Heater Water Valve – Knocking Noise
During Climate Control Operation –
Repair Procedure

MODEL 1995 MY
Sedan Range
VIN
720001 - 739750

ILLUSTRATION 1

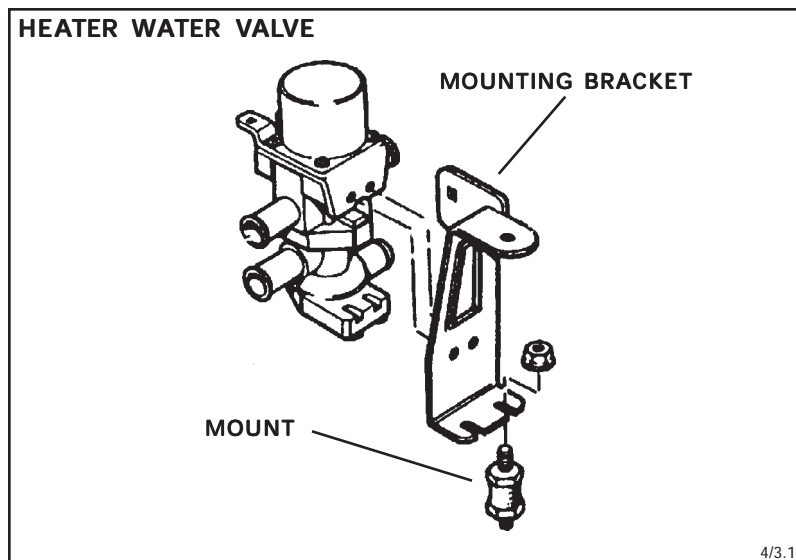
1. Remove the heater valve and mounting bracket assembly from its three mounts (Illustration 1).
2. Remove the three existing heater valve mounts ("Instrumounts"). Replace the mounts with three new mounts (part number MNA 6730AB).

3. Refit the heater valve.
